SKILLING, HELLE, CHRISTIANSEN, ROBERTSON — Structural & Civil Engineers

PROJECT: THE WORLD TRADE CENTER | TITLE: LOUVER SUPPORT REPAIRS - FL. 108 | DATE: 2/5/71

19-A-991.1

Detail 991A

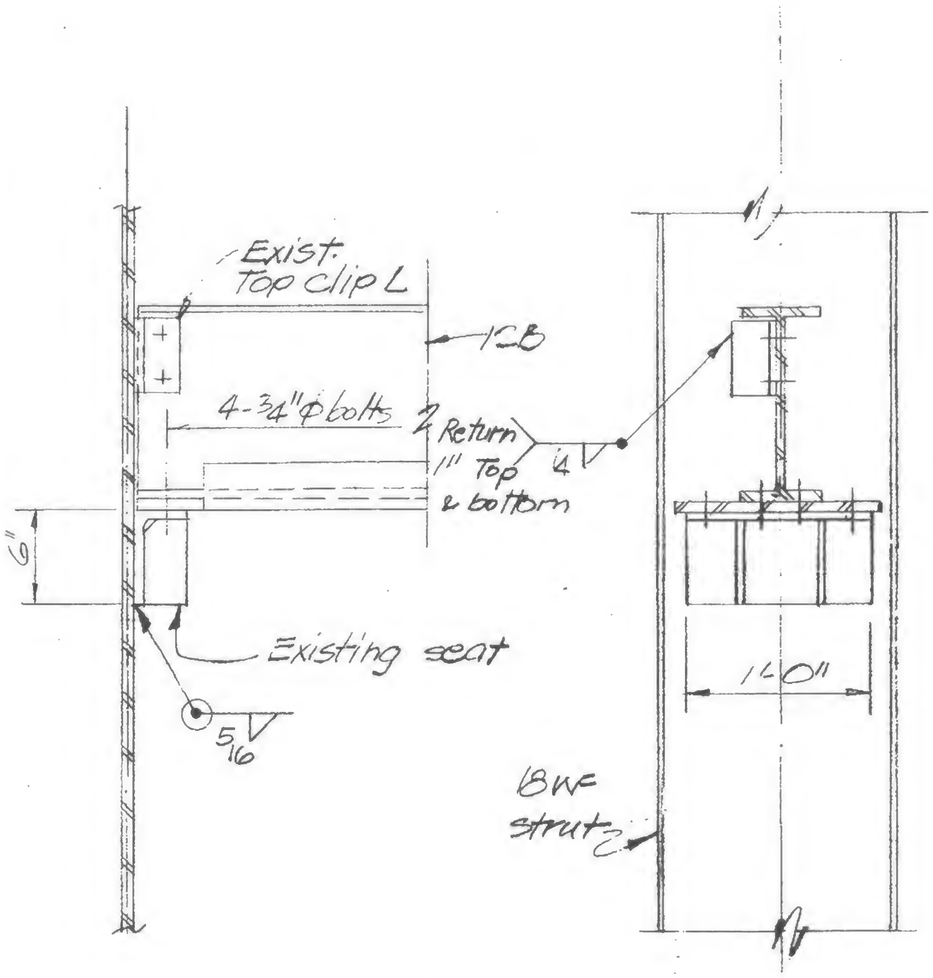
Remove existing connection material, relocate beam and reweld existing connection material to 18WF strut.

Detail 991B

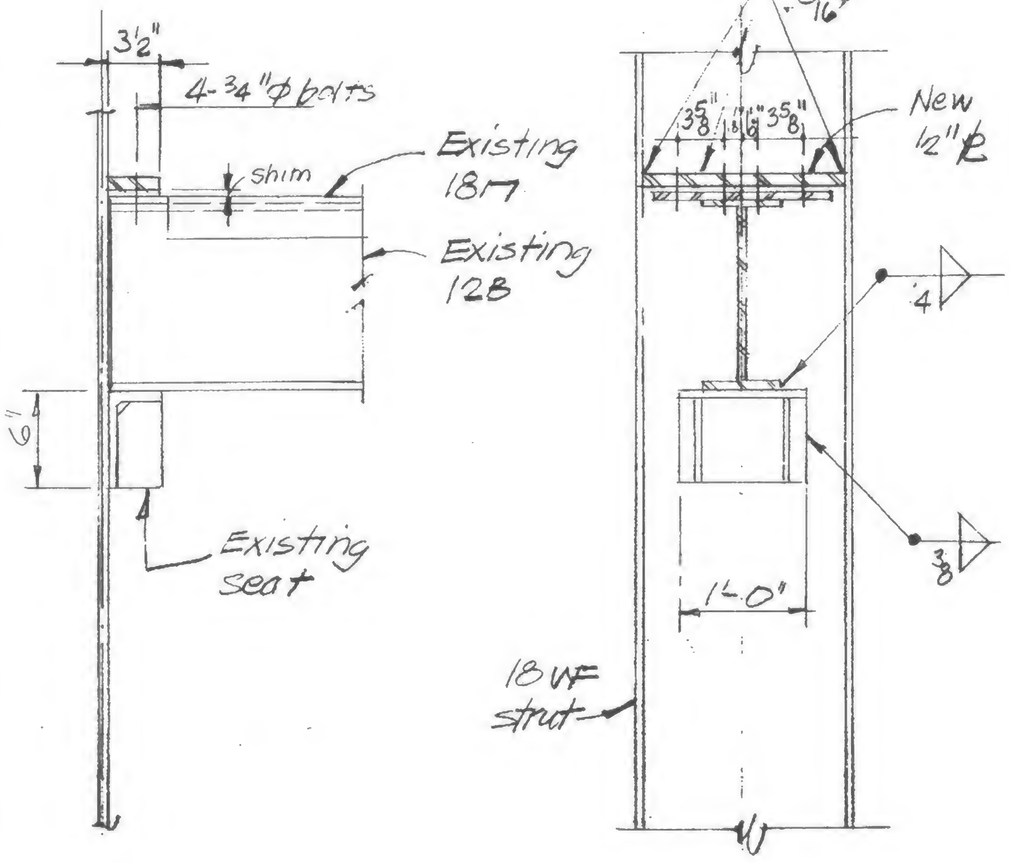
Remove existing connection material, rotate channel beam, assemble to position indicated in elevation, reweld existing connection material to 18WF strut and install new material as indicated.
